Access Compliance Report

Public Rights-of-Way

(Curb Ramps)

Intersection ID: 15477	Main Street: W_TYVOLA_RD	Cross Street: CASCADE_POINTE_BV	Location:	N
ADA ID: 6480D44E4FB3	Ramp Type: Perp	Initial Pass/Fail: Fail	Overall Compliance: No	Severity Score: 35
Codes/Mitigation Info/Possible Solution		Field Measurements/Component Compliance

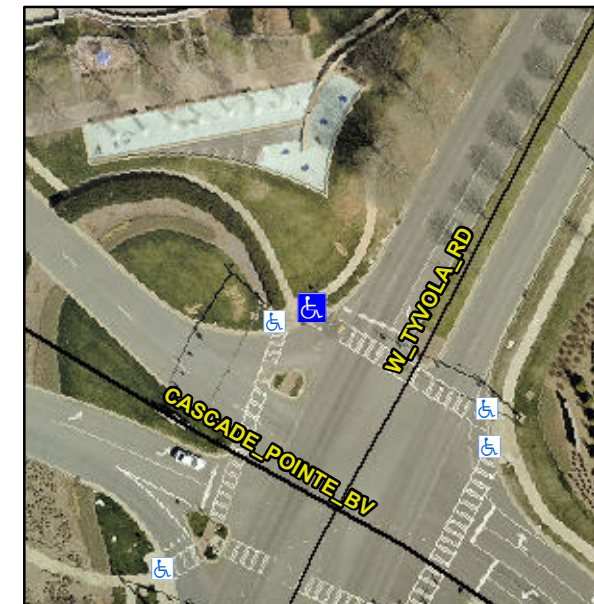
Not Found, R304.5.1, R304.2.2, R304.5.3

Compliance	Description	Data	Compliance	Description	Data
N/A	Ramp Length (in)	77.0	No	Ramp Slope (%)	15.1
No	Ramp Width (in)	41.0	No	Ramp XSlope (%)	3.3
N/A	Flare Type LT	N/A	N/A	Flare Type RT	N/A
N/A	Flare Slope LT (%)	N/A	N/A	Flare Slope RT (%)	N/A
N/A	Flare Traversable LT?	N/A	N/A	Flare Traversable RT?	N/A
N/A	Landing Length (in)	N/A	N/A	DWS Provided?	N/A
N/A	Landing Width (in)	N/A	N/A	DWS Contrast?	N/A
N/A	Landing Slope (%)	N/A	N/A	DWS Length (in)	N/A
N/A	Landing X Slope (%)	N/A	N/A	DWS Full Width?	N/A
N/A	Landing Curb? (Y/N)	N/A	N/A	DWS Offset (in)	N/A
N/A	Shared Landing?	N/A			
N/A	Gutter Ponding?	N/A	N/A	Gutter Slope (%)	N/A
N/A	Gutter Lip Ht (in)	N/A	N/A	Gutter X Slope (%)	N/A
N/A	Painted X Walk1?	Yes	N/A	Painted X Walk2?	N/A
	X Walk 1 Direction	To SW		X Walk 2 Direction	N/A
N/A	X Walk 1 Width (in)	112.0	N/A	X Walk 2 Width (in)	N/A
	X Walk 1 Slope (%)	1.3		X Walk 2 Slope (%)	N/A
	X Walk 1 X Slope (%)	2.2		X Walk 2 X Slope (%)	N/A

Remove & Replace Entire Ramp.
